The Calcutta Gazette

APPENDIX.

NOTICES TO MARINERS.

The following Notices are republished for general information.

Reproduction of Portion of Chart N° 942a.

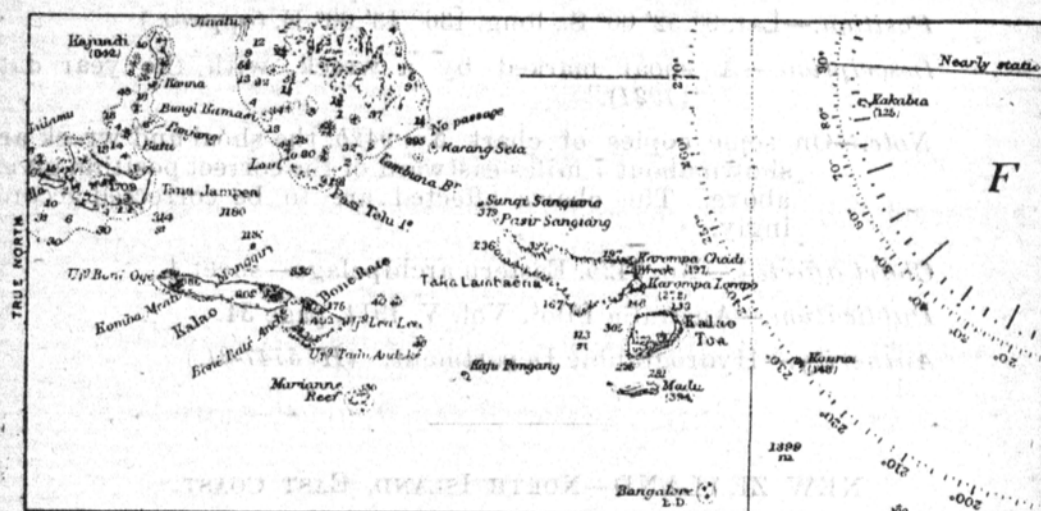
Note.—On some copies of chart No. 942b, the shoal and wreck are shown about 7 miles eastward of the correct position given above. The charts affected are to be corrected accordingly.

Reproduction of Portions of Chart No. 1102

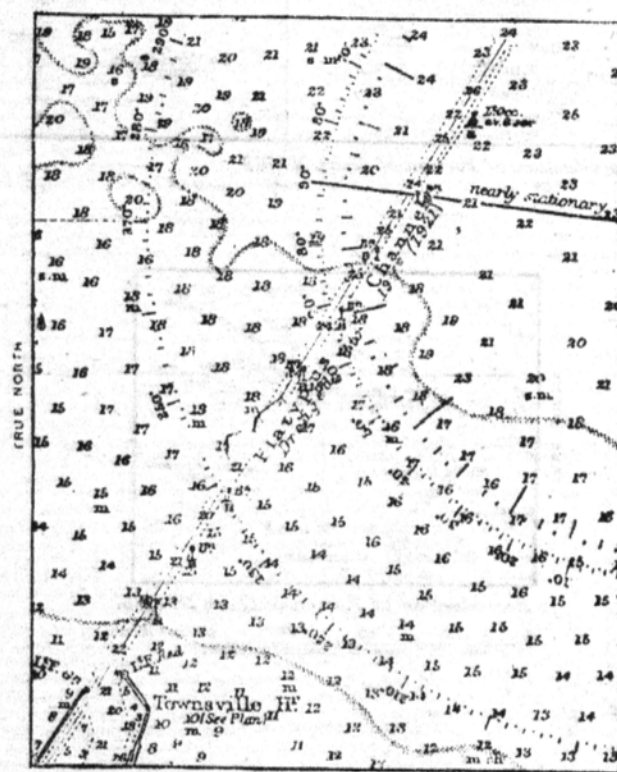
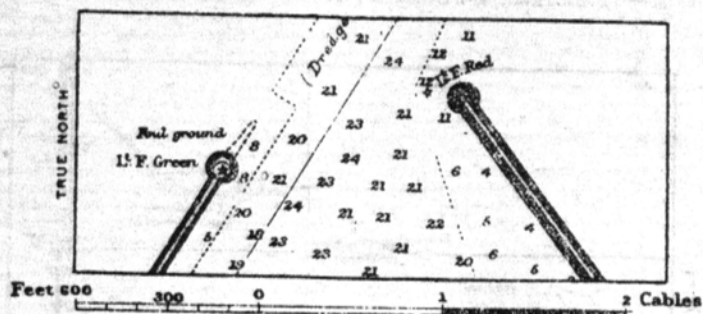
Details.—The accompanying reproduction of a portion of chart No. 1102 shows the necessary amendments to the chart with regard to Platypus channel, in the approach to Townsville harbour. Attention is drawn to the establishment of eight black beacons, the withdrawal of three conical black buoys, the alteration in the position of the light-buoy marking the north-eastern end of the dredged channel and the existence of foul ground off the north-eastern extremity of the Western breakwater. The fixed green light near the seaward end of Western breakwater has been moved a distance of 200 feet (61m0) to the north-eastward.

Note.—Tidal signals are no longer made from Bay rock and the note on chart No. 1102 is to be amended accordingly.

Reproduction of Portion of Chart N° 769

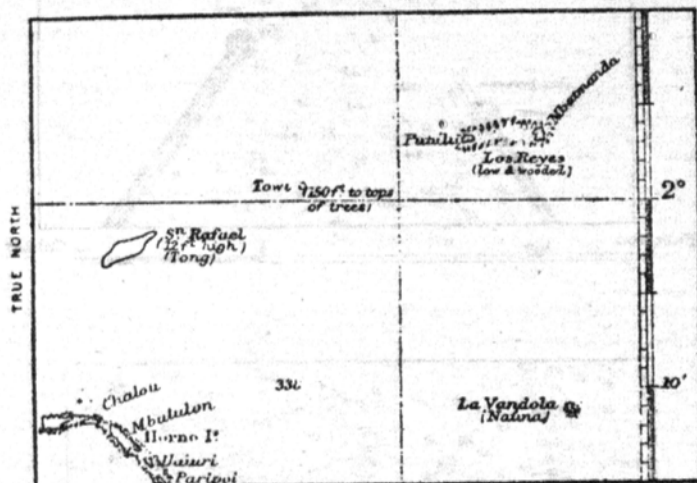
Details.—The accompanying reproduction of portions of charts Nos. 769 and 2766 shows the necessary amendments to the charts with regard to the positions of La Vandola (Nauna) and San Rafael (Tong) islands, also the height of the trees on Towi island.

Reproduction of Portion of Chart No. 1100

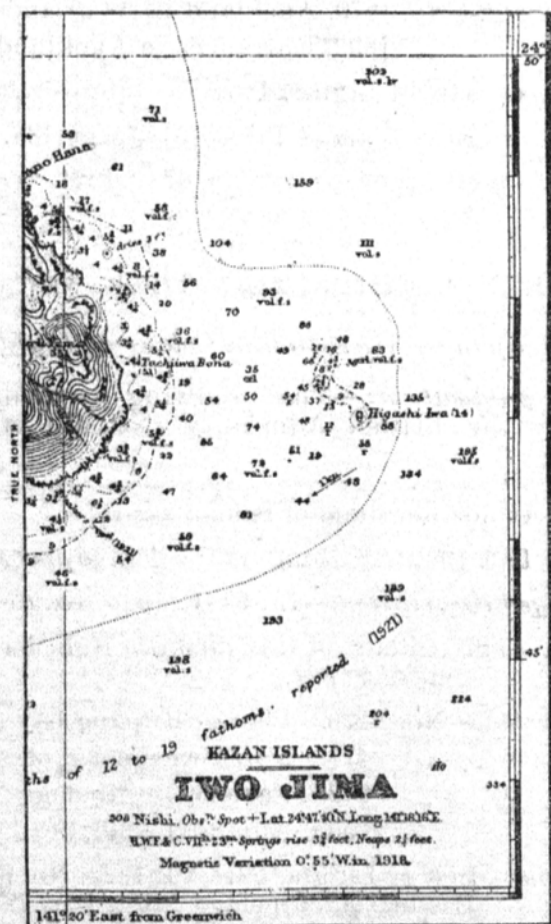
Details.—The accompanying reproduction of a portion of the plan of Iwo jima on chart No. 1100 shows the necessary corrections to that plan with regard to a shoal extending north-westward from Higashi iwa and depths in the vicinity.

Note.—It will be observed that the note with regard to rocks and breakers reported between Iwo jima and Higashi iwa has been omitted from the reproduction.

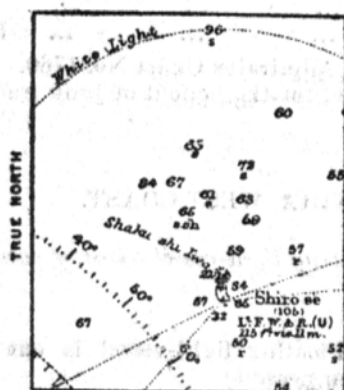
The rock, the existence of which was doubtful, reported in the year 1914 about $1\frac{1}{2}$ miles northward of Shiro se lighthouse, does not exist and is therefore omitted from the reproduction.

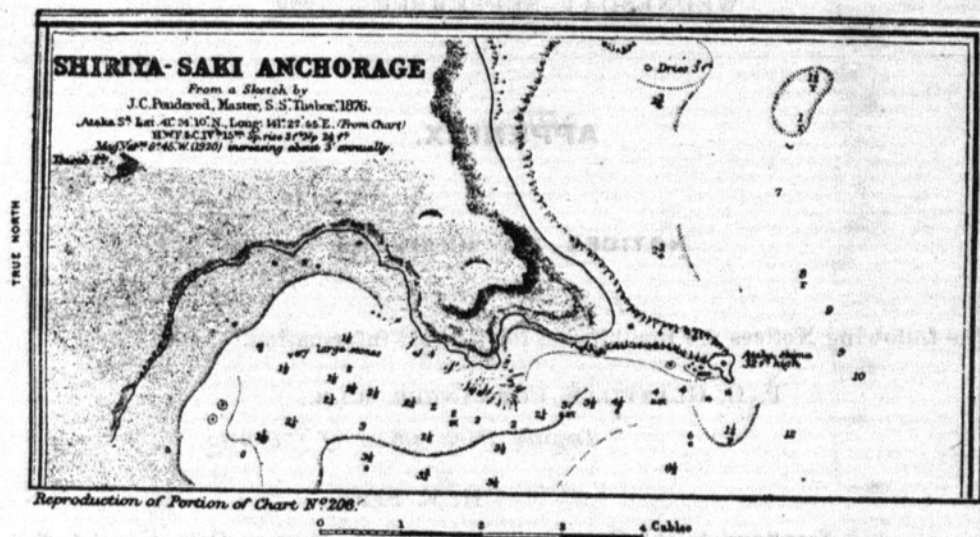
Details.—General amendments to the chart with regard to the coastline and rocks in the vicinity of Ataka shima are shown on the accompanying reproduction of a portion of the undermentioned plan on chart No. 208.

Remarks.—The symbol for a rock with a depth of less than 6 feet ($1^m 8$) is to be inserted in lat. $41^{\circ} 24' 40'' N.$, long. $141^{\circ} 28' 10'' E.$ on chart No. 2441.

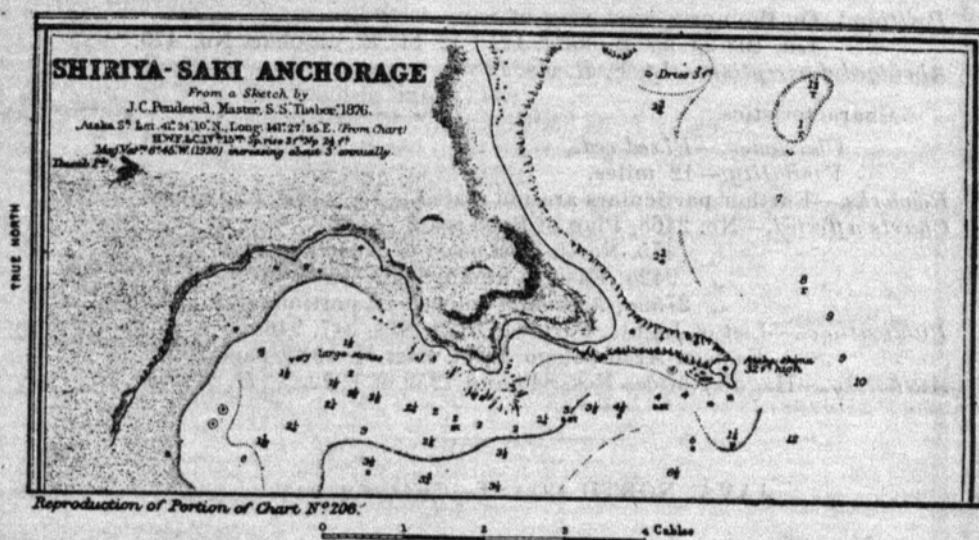
Details.—General amendments to the chart with regard to the coastline and rocks in the vicinity of Ataka shima are shown on the accompanying reproduction of a portion of the undermentioned plan on chart No. 208.

Remarks.—The symbol for a rock with a depth of less than 6 feet ($1^m 8$) is to be inserted in lat. $41^{\circ} 24' 40'' N.$, long. $141^{\circ} 28' 10'' E.$ on chart No. 2441.

Reproduction of Portion of Chart No. 776

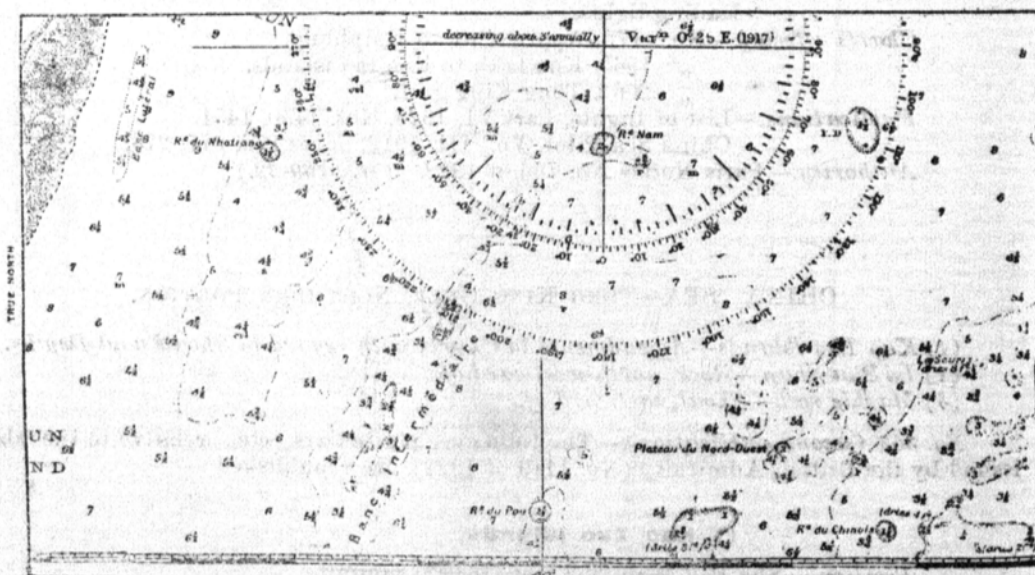
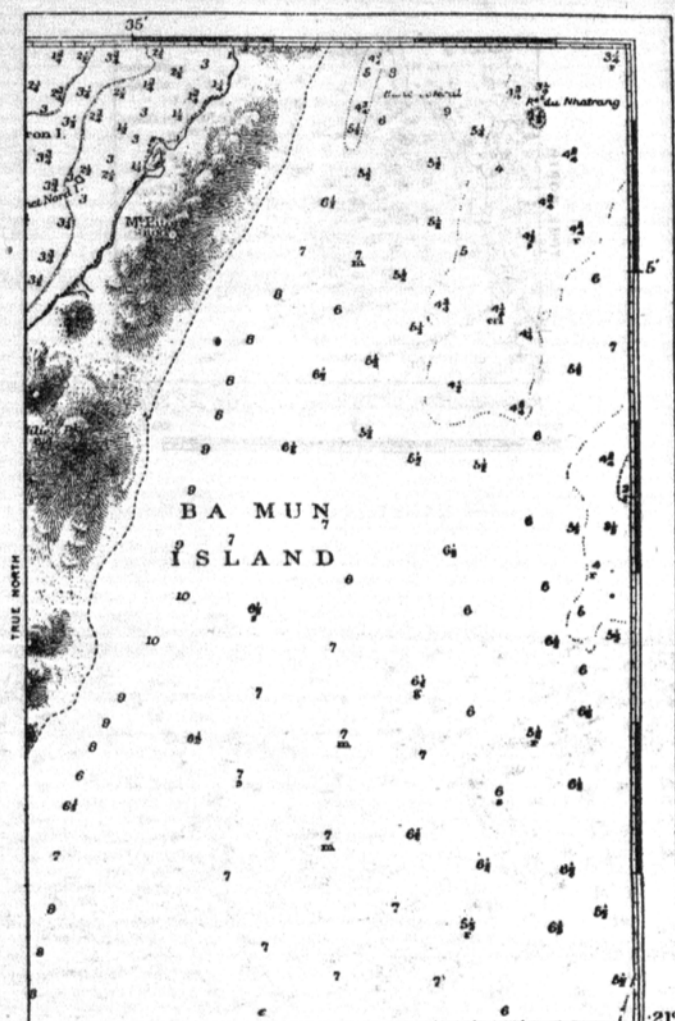
Details.—The accompanying reproductions of portions of charts Nos. 776, 1965, 1169, 2062 and 2661a, show the necessary amendments to the charts with regard to shoals and depths in the vicinity of, and to the westward of the Kao Tao islands. The depth on Hugon rock at the southern end of Sanglier island is one fathom (1^m8), and not 1½ fathoms as hitherto shown on the charts.

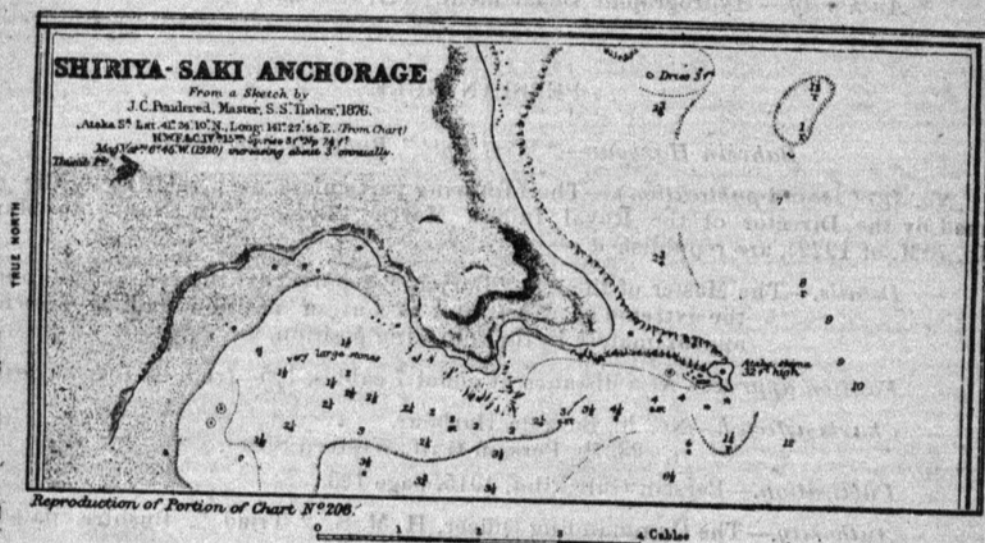
Details.—General amendments to the chart with regard to the coastline and rocks in the vicinity of Ataka shima are shown on the accompanying reproduction of a portion of the undermentioned plan on chart No. 208.

Remarks.—The symbol for a rock with a depth of less than 6 feet ($1^m 8$) is to be inserted in lat. $41^{\circ} 24' 40'' N.$, long. $141^{\circ} 28' 10'' E.$ on chart No. 2441.

Reproduction of Portion of Chart N° 1169.

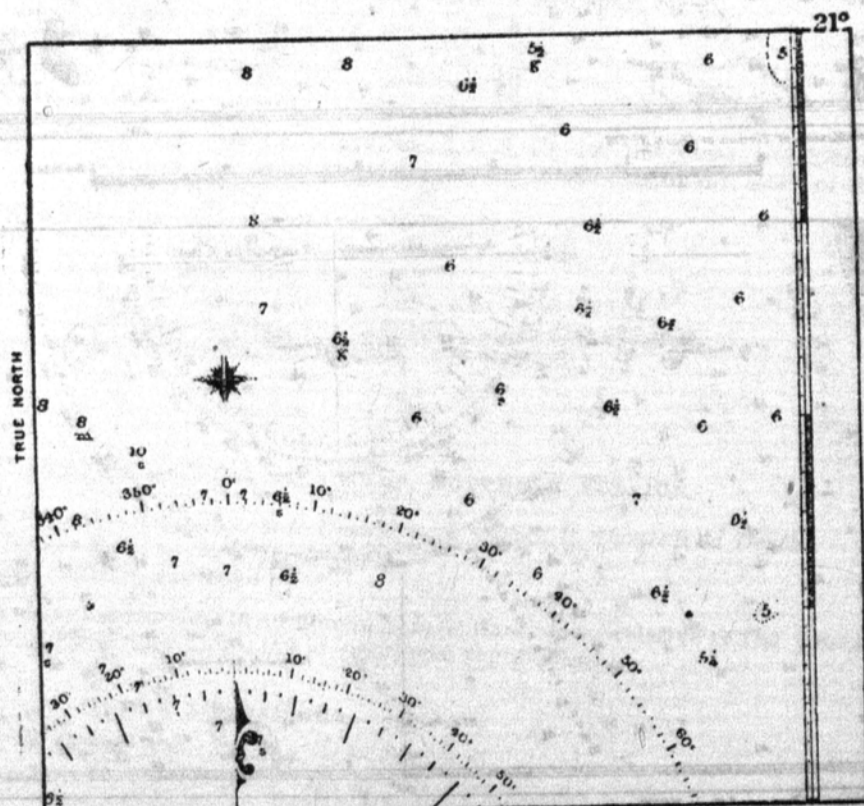
Details.—The accompanying reproductions of portions of charts Nos. 776, 1965, 1169, 2062 and 2661a, show the necessary amendments to the charts with regard to shoals and depths in the vicinity of, and to the westward of the Kao-Tao islands. The depth on Hugon rock at the southern end of Sanglier island is one fathom (1^m8), and not 1½ fathoms as hitherto shown on the charts.

Reproduction of Portion of Chart N°986.

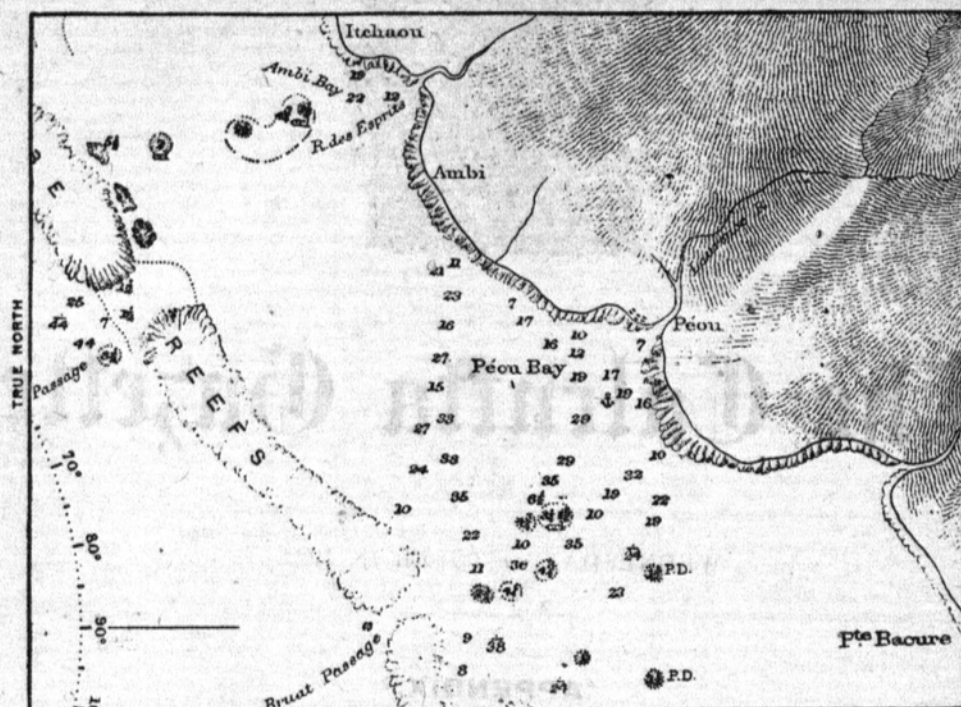
Details.—The accompanying reproductions of portions of charts Nos. 986 and 17 show the necessary amendments to the charts with regard to coastline, reefs, shoals and depths in the vicinity of Péou and Ambi bays.
